ORIGINATION FORM

Proposed Revisions to a Standard Plans Index

Index Number: 715-002

Index Title: STANDARD ALUMINUM LIGHTING

SHAFT FOUNDATION ELEVATION

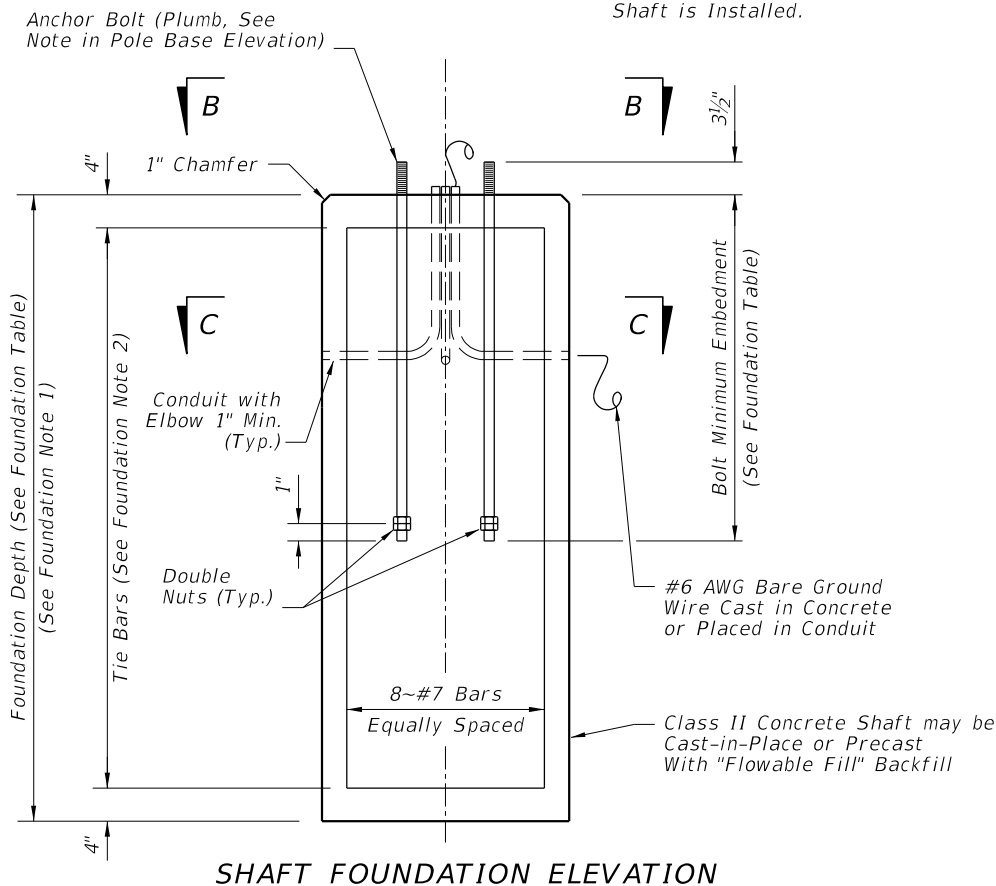
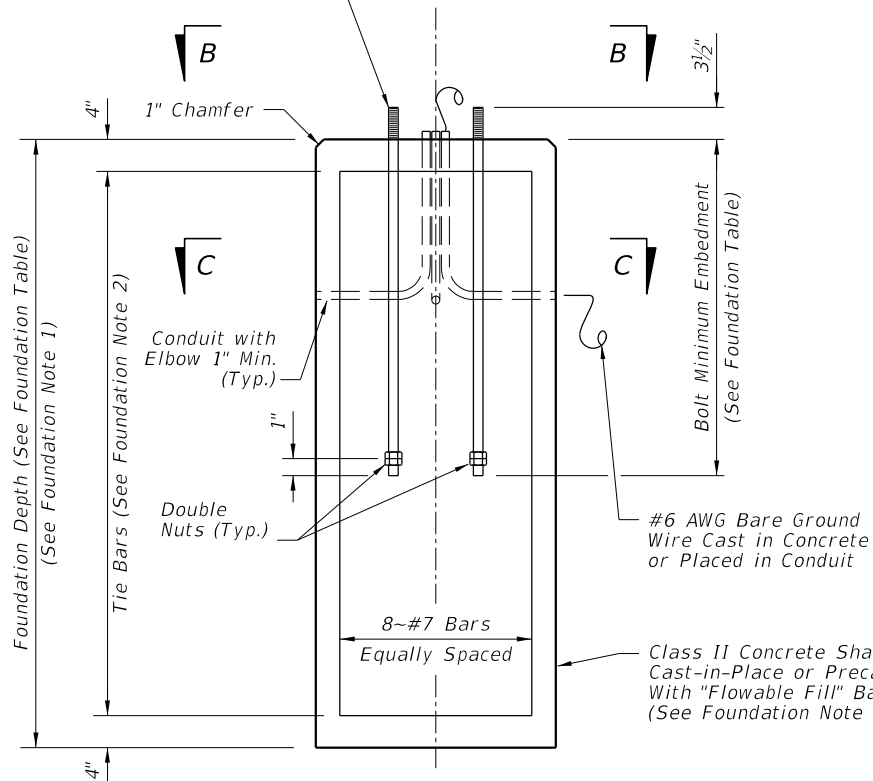
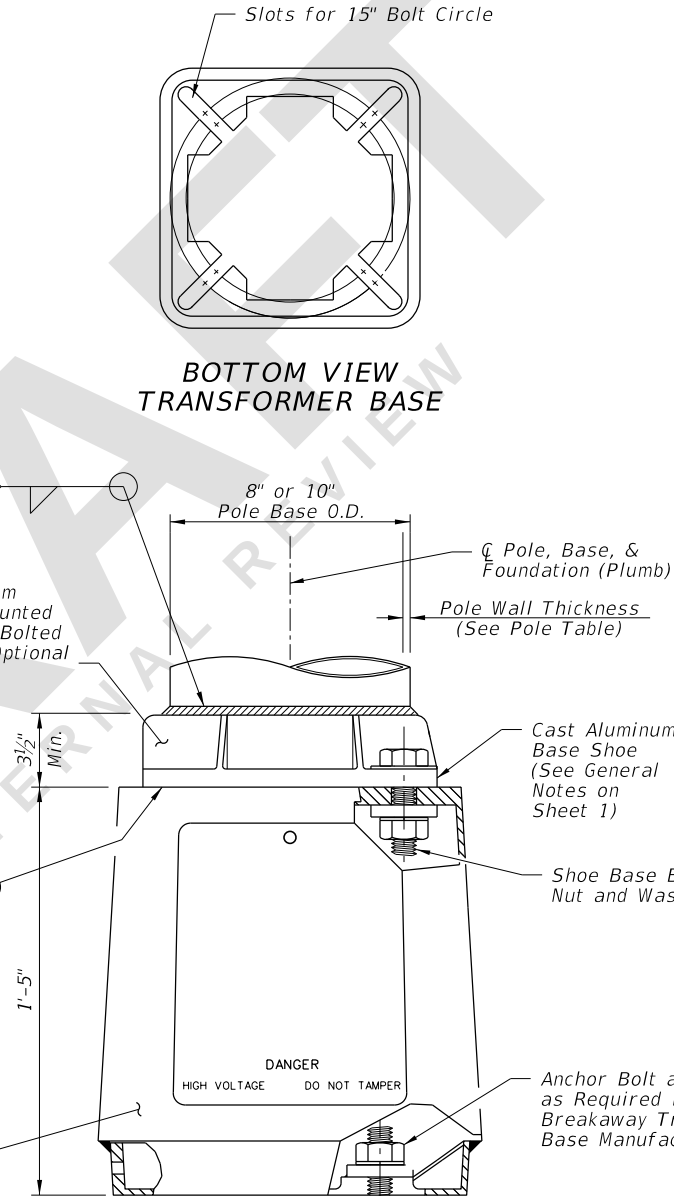
Sheet 4: Added Shaft Foundation Note 3 to allow for concrete foundation with an octagon shape as a substitute for the circular shaped shaft foundation shown.

Sheet 4: A non-circular, octagon shaft option was requested by industry to simplify formwork.

Added Note 3 for new precast option with octagon shape shaft foundation

1. Depths shown are for slopes equal to or flatter than 1:4. For slope steeper than 1:4 and equal to or flatter than 1:2 add 2'-6" to foundation depths shown.
2. Foundation Tie Bars: #4 Tie Bars @ 12" centers (max.) or D10 (or W10) spiral @ 6" pitch, 3 flat turns top and 1 flat turn bottom.
3. For precast foundations, the circular cross section shown herein may be substituted with an octagon shape. The out-to-out distance between parallel edges of the octagon must be $\geq$ 2'-6". Maintain the reinforcing diameter and placement shown herein with a minimum 3" cover.

SPREAD FOOTING FOUNDATION OPTION

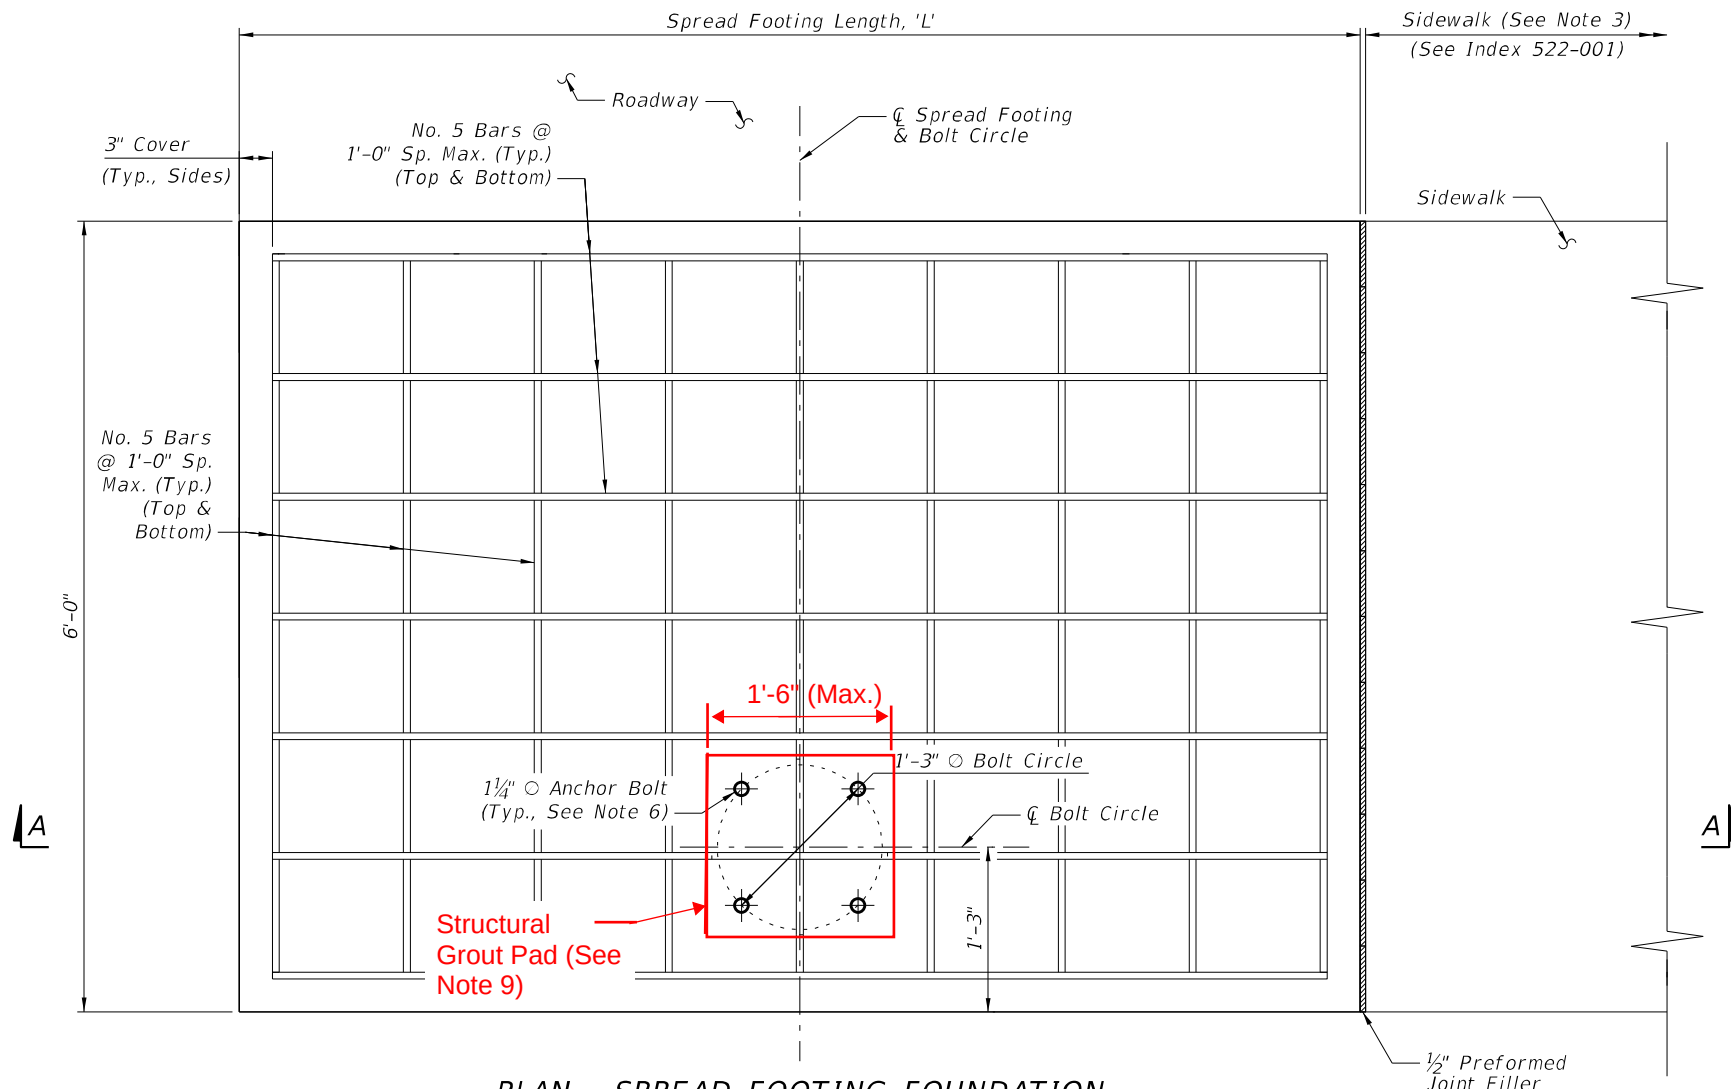
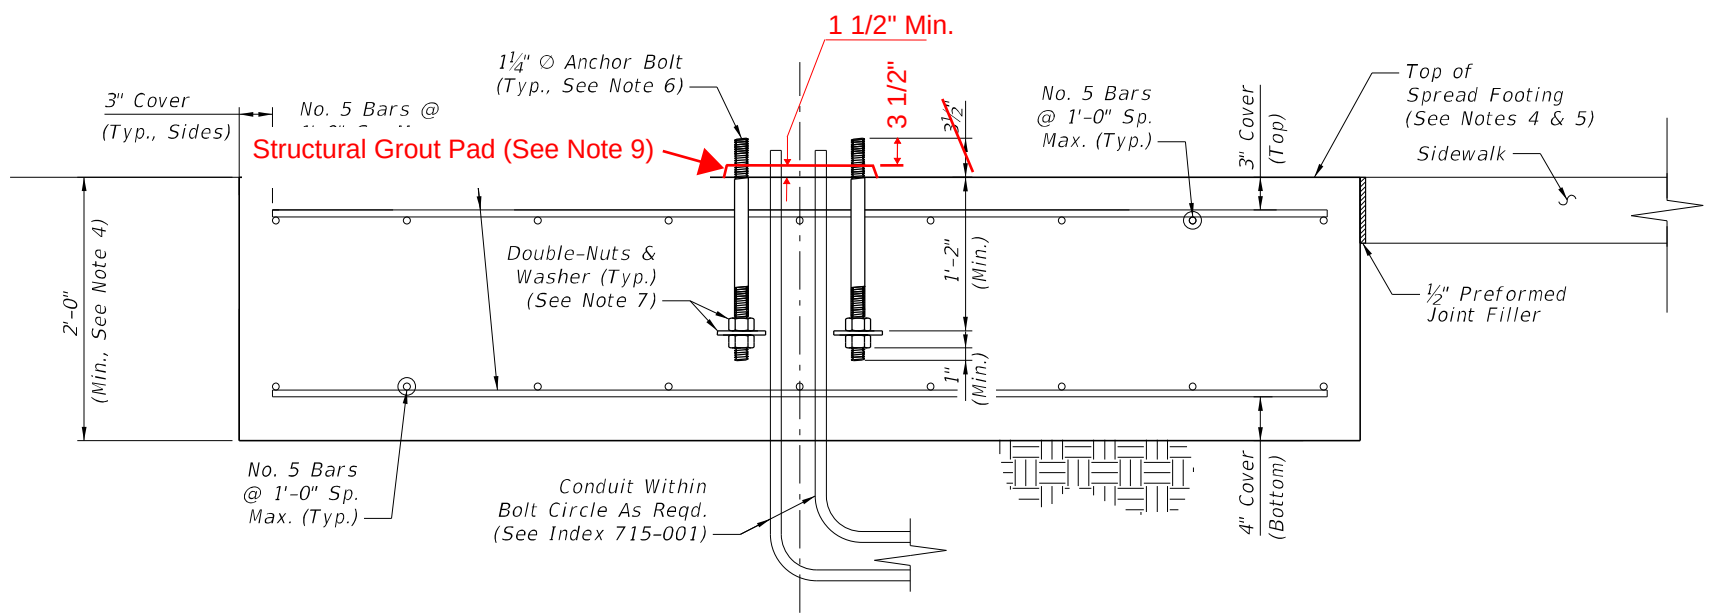
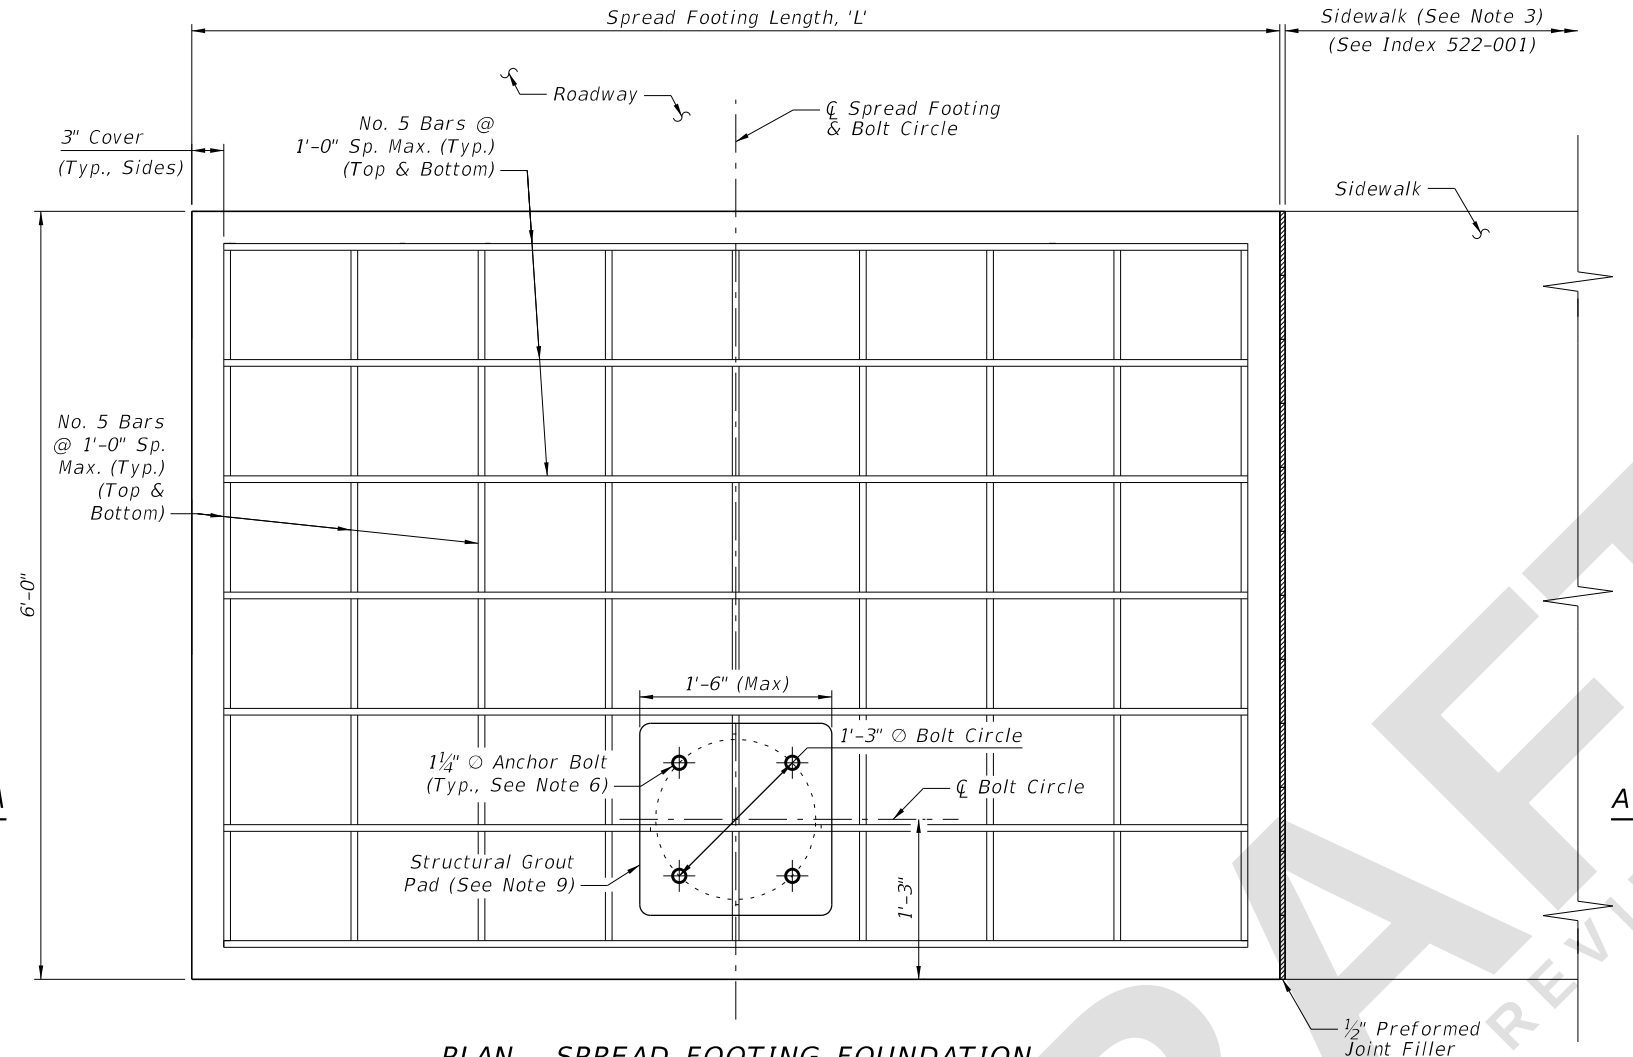
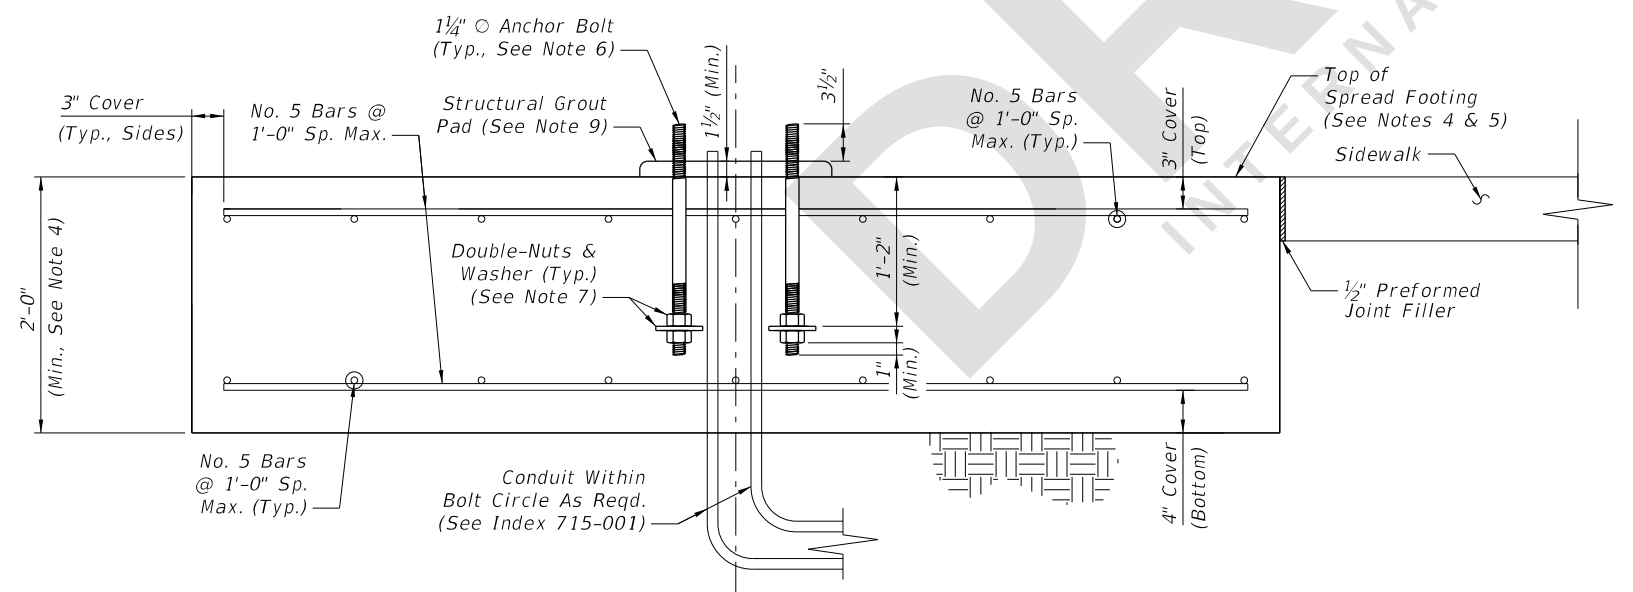
Sheet 5: Added new structural grout pad details to the plan and section view. Added new Note 9 to explain structural grout pad construction and reference specification.

Sheet 5: At the request of the Districts, a grout pad is added to assist with constructibility and leveling of the light pole.

Added Note 9 for new Structural Grout Pad details

9. Place a structural grout pad in accordance with Specification 649-9. The grout pad is square and centered on the bolt circle centerlines. Level the top of the grout pad and smooth the edges and corners per the approval of the Engineer. Install the transformer base in accordance with Sheet 4 and the manufacturer's specifications.

BASE PLATE DETAILS FOR MEDIAN BARRIER MOUNTED ALUMINUM LIGHT POLE

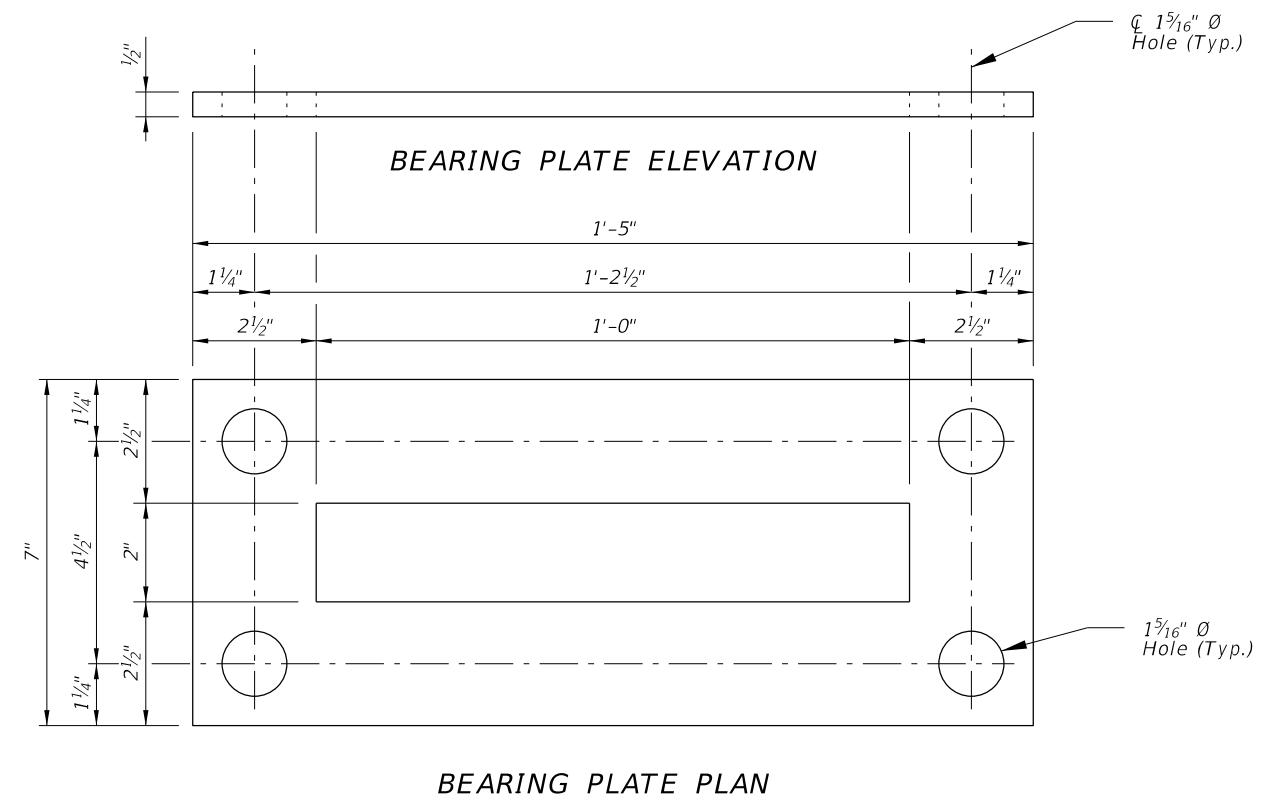
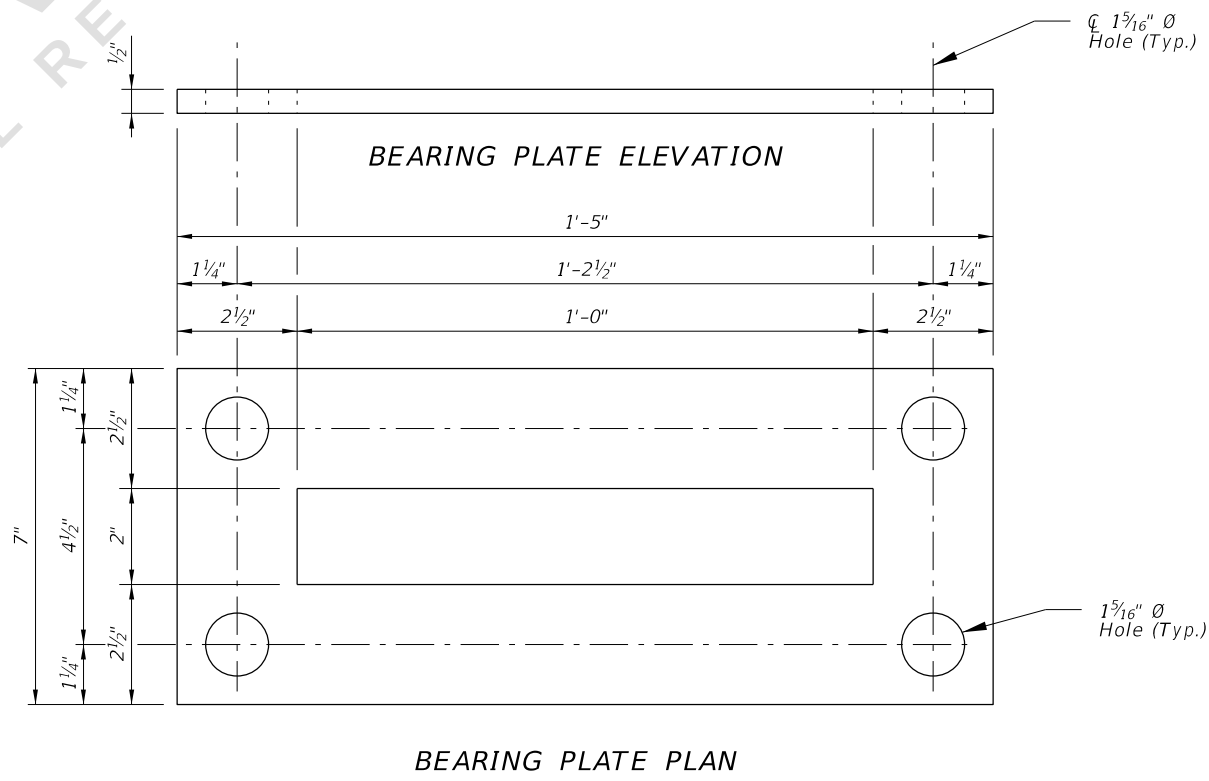
Sheet 6: Changed weld detail to say "CJP."

Sheet 6: Changing non-standard language to standard language consistent with AWS. Spec 460 will accompany the revision. This revision is being managed by Josh Turley in the SDO.
